- Subject** ▶ Modification of Motor Bracket and addition of Dust Cover Set
- For Models** ▶ 3612BR
- Country** ▶ All countries
- Description** ▶ Dust Cover Set has been introduced as an optional accessory. Consequently, two bosses have been added on the Motor Bracket so that the Dust Cover Set can be installed.

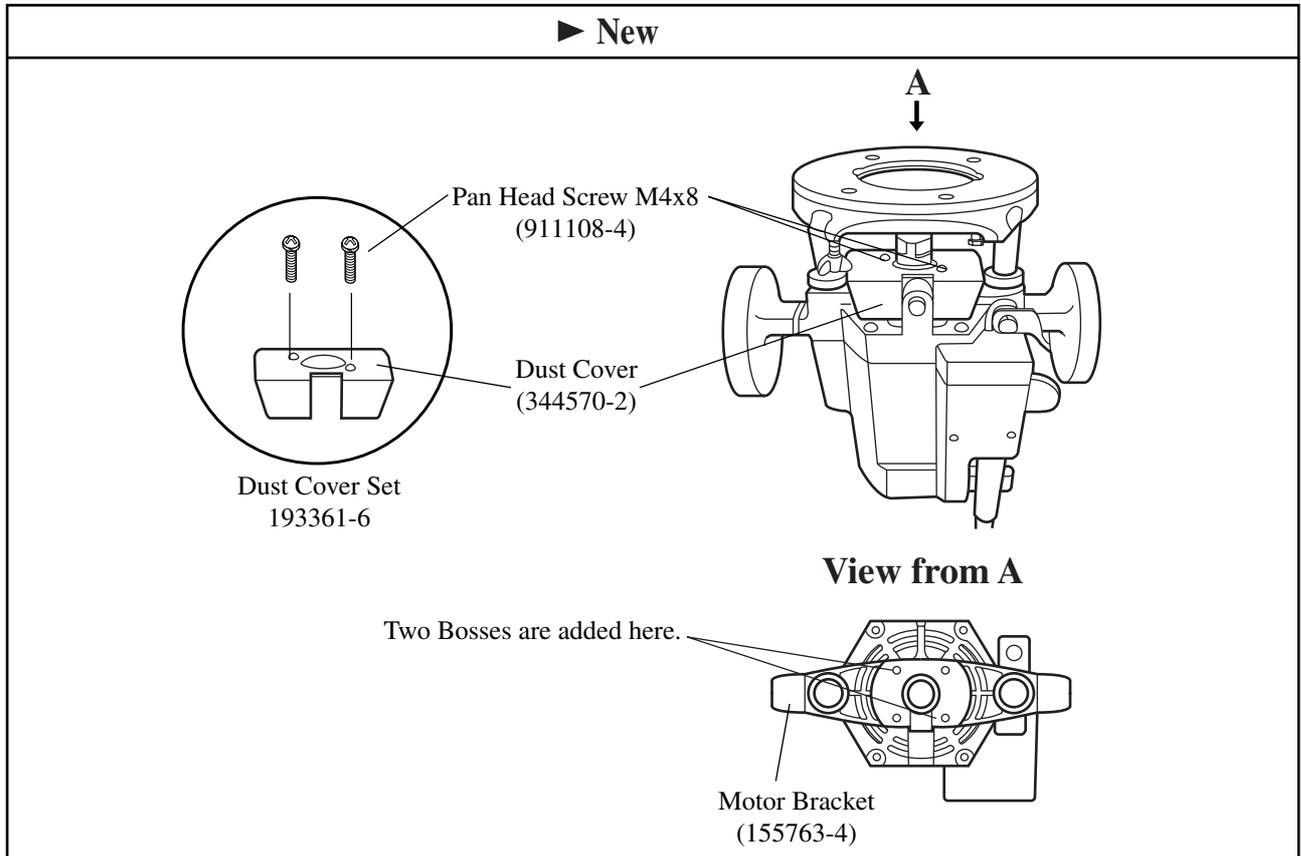
1. Dust Cover Set consists of Dust Cover (344570-2) and 2 pieces of Pan Head Screw M4x8 (911108-4).
2. The part No. of Motor Bracket Complete remains unchanged. Distinguish the new Motor Bracket Complete from the current one by checking the two bosses. The Dust Cover Set cannot be installed on the current Motor Bracket Complete.
3. Interchangeability mark ; ← means that the new part is substituted for the current.
